RESPONSE TO REQUEST FOR ADDITIONAL INFORMATION

APR1400 Design Certification

Docket No. 52-046

RAI No.: 275-8294
SRP Section: 04.02 – Fuel System Design
Application Section: 4.2
Date of RAI Issue: 10/27/2015

Figure 04.02-3-1 Simplified beam model and pluck impact simulation model

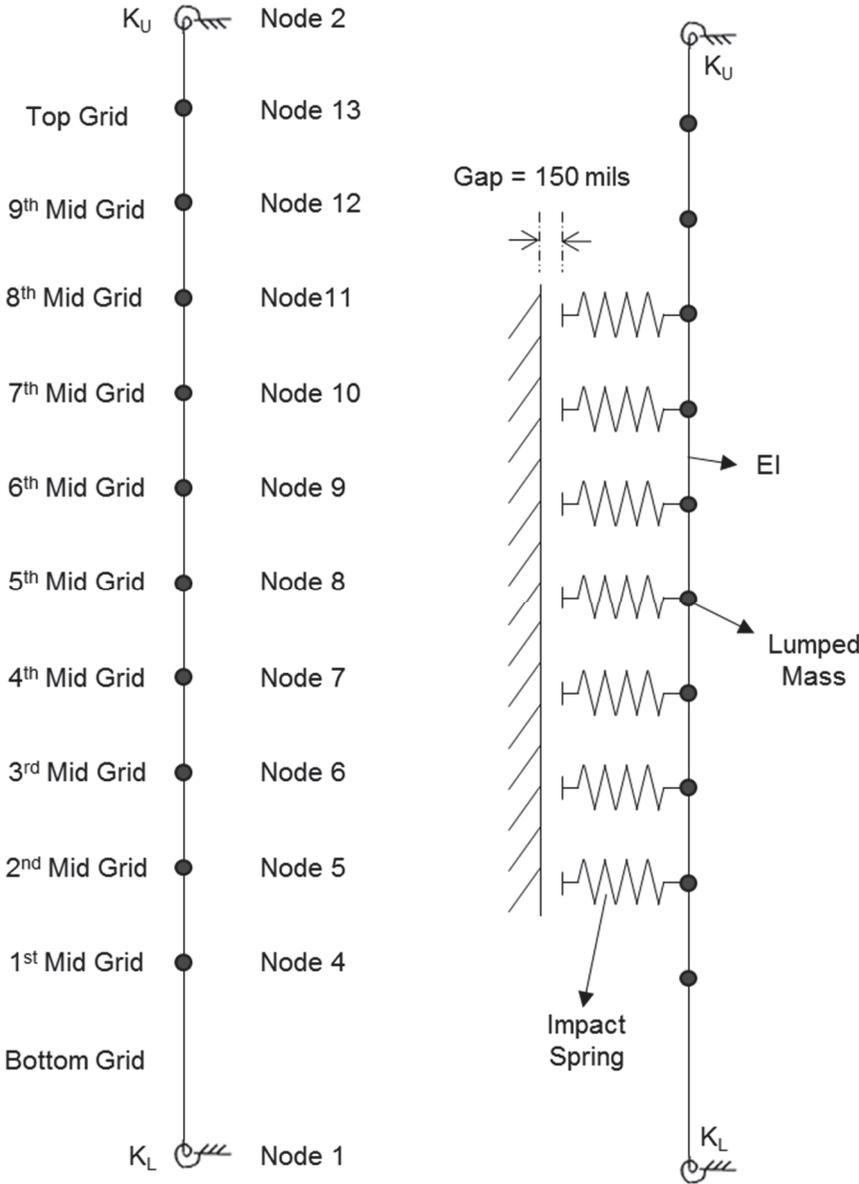
Figure A.2-6 of APR1400-Z-M-NR-14010-P demonstrates that the PLUS7 fuel assembly design exhibits nonlinear behavior, with a natural frequency that varies with vibrational amplitude. This has caused the staff to question the adequacy of the linear lateral vibrational model used in the analysis to model fuel assembly behavior.

Staff requests the applicant provide justification for the use of a linear fuel assembly model to represent the PLUS7 fuel assemblies and update the technical report, if necessary.

The fuel assembly (FA) seismic/LOCA methodology in Technical report APR1400-Z-M-NR-14010-P was prepared based on CENPD-178-P, Rev. 1-P (CENPD-178). Section 6.2.4.2 of CENPD-178 describes that one purpose for pluck impact simulation is to validate the fuel assembly modelling technique. Similar to CENPD-178, the linear model that represents the PLUS7 FAs was developed considering nonlinear characteristics at large amplitude and verified through comparison of the pluck impact test and pluck impact simulation. The comparison results clearly show that the model provides good agreement with the test data. Detailed information is described as follows:

Figure 04.02-3-1 shows a simplified beam model and a pluck impact simulation model for a fuel assembly. Nodes are located at grid center elevations and are connected to each other with beam elements. Each span weight is lumped at grid node and a rotational spring is attached at the end of each fuel assembly.

Using the force equilibrium equation with a torsional spring at each end, the normalized deflection shape of the model is expressed in terms of two non-dimensional parameters, α_1 and α_2 . The optimized values are obtained by minimizing the difference in the lateral deflection between the test result and the model as shown in Table 04.02-3-1. Using two non-dimensional parameters, α_1 and α_2 , and fuel assembly 1st mode natural frequency from the lateral vibration test, beam rigidity (EI) and two rotational spring stiffnesses (K_L , K_U) are calculated, respectively.
